Burlington Design Advisory Board

DESIGN ADVISORY BOARD Tuesday January 12, 2021 3:00 PM REMOTE MEETING

- 1. 21-0583CA; 52 Institute Road (RCO, Ward 4N) Burlington School Dept.**
Expansion and renovation of Burlington High School and Technical Center.

To: The Design Advisory Board
From: Mary O'Neil, AICP, Principal Planner
RE: ZP21-0583CA, 52 Institute Road (BHS)
Date: January 12, 2021

L-100
ALT

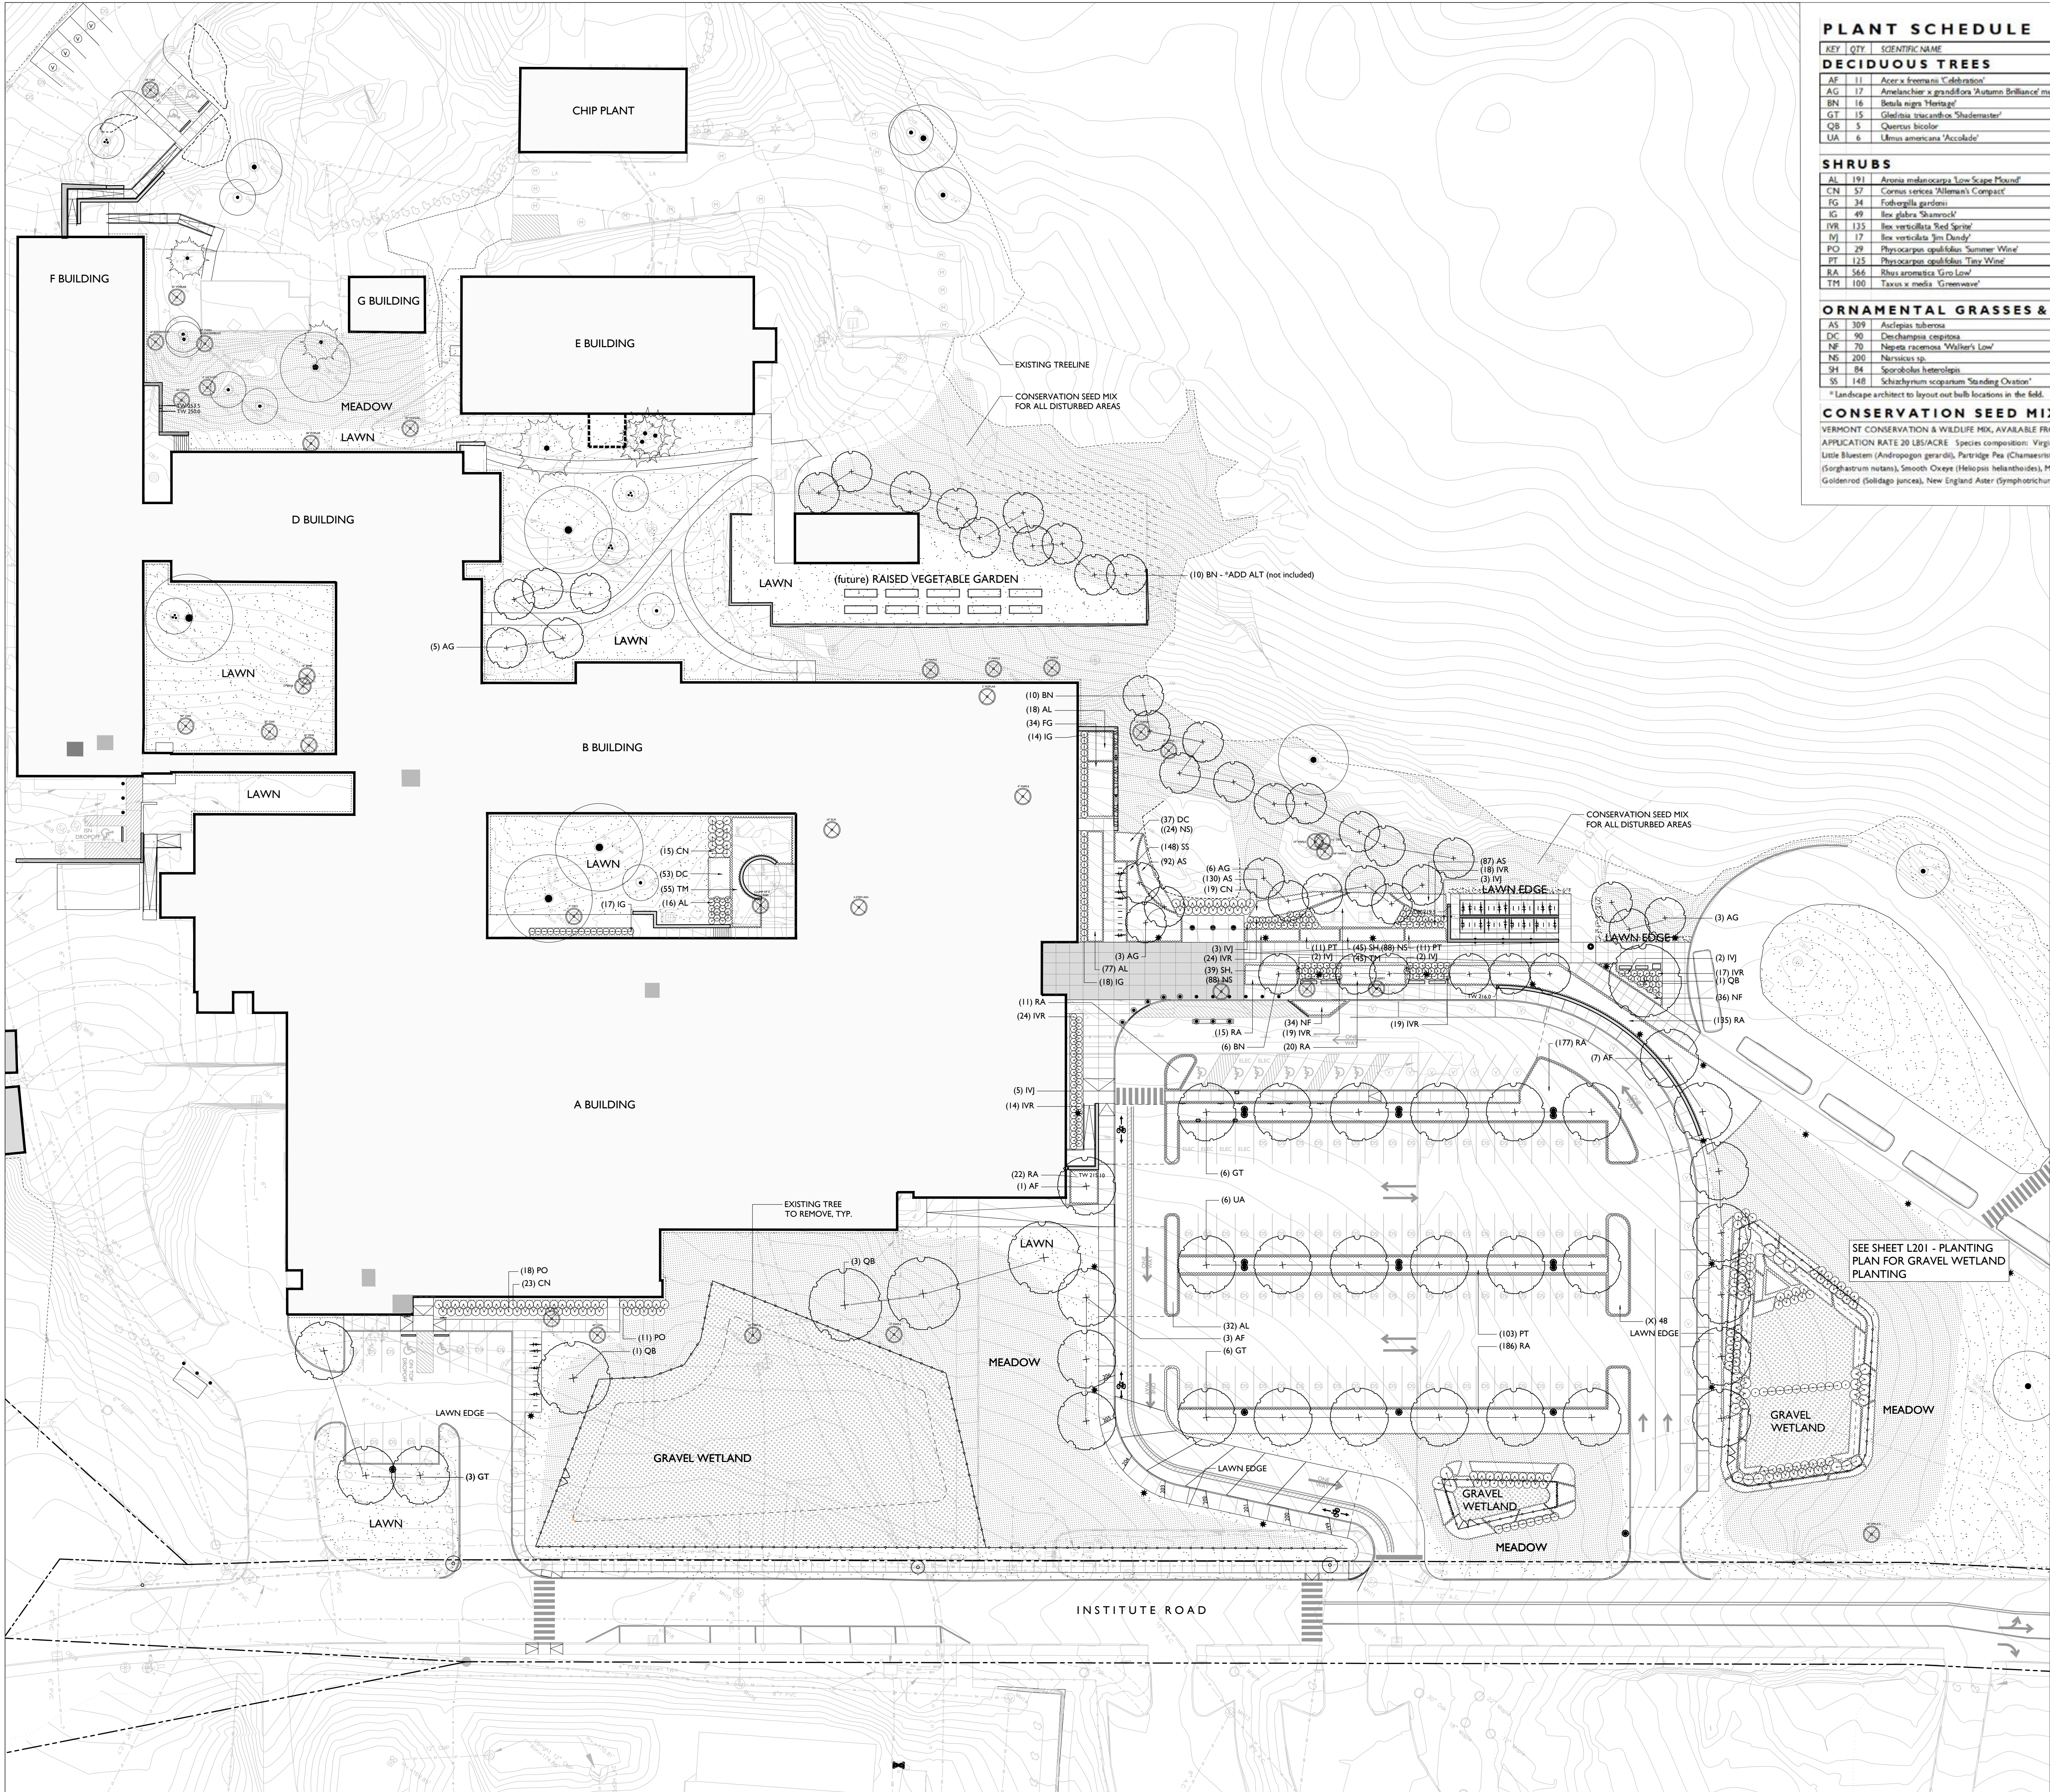
Reference is made to Plan L100 ALT, which includes the attached parking table.

The forecasted decrease in parking spaces (-6) and discussion of required parking is addressed in an overall parking management plan. See p. 68-71 in overall submission packet.
